**DATE:** September 13, 2023  
**TO:** Connie Anderson, T&B Planning, Inc.  
**FROM:** Charlene So, Urban Crossroads, Inc.  
**JOB NO:** 14668-05 Memo

## **PALMDALE LOGISTICS PARK SITE PLAN REVIEW**

### EXHIBIT 1: SITE PLAN USED IN TECHNICAL STUDIES

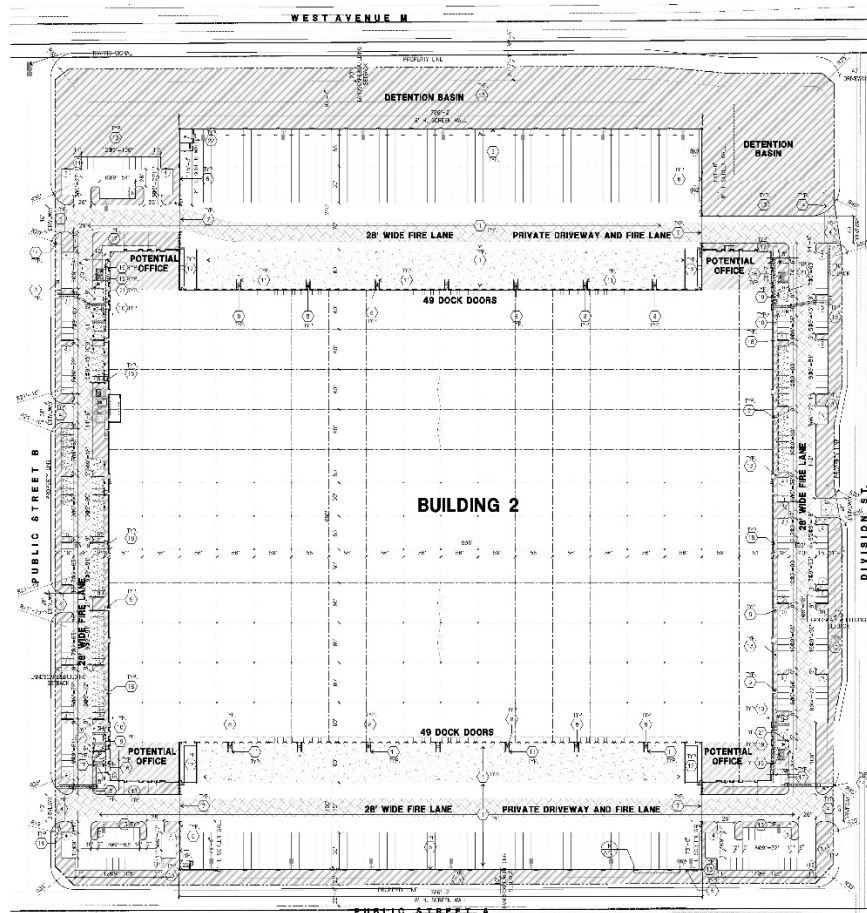
The technical studies listed above present a site plan consisting of two warehouse buildings totaling 1,420,070 square feet (Building 1 = 716,930 square feet and Building 2 = 703,140 square feet) although the analyses are based on a higher square footage of 1,429,700 square feet. There is a new public street proposed that will run north-south between the two buildings (Street B) and a new public street along the southern boundary of both buildings that would connect to Division Street (Street A). Building 1 is proposed to have passenger car and truck access to both Street and Street B, Building 2 would have access to Street B and Division Street. Neither building would have direct access to Avenue M. Specifically, Building 1 has a driveway on Street A (Driveway 1) and four driveways along Street B (Driveway 2 through Driveway 5). Building 2 proposes driveways along Street B that align with the locations of the driveways serving Building 1 (Driveway 2 through Driveway 5). There are four additional driveways proposed along Division Street (Driveway 6 through Driveway 9). The site plan included in the technical studies is shown on Exhibit 1.
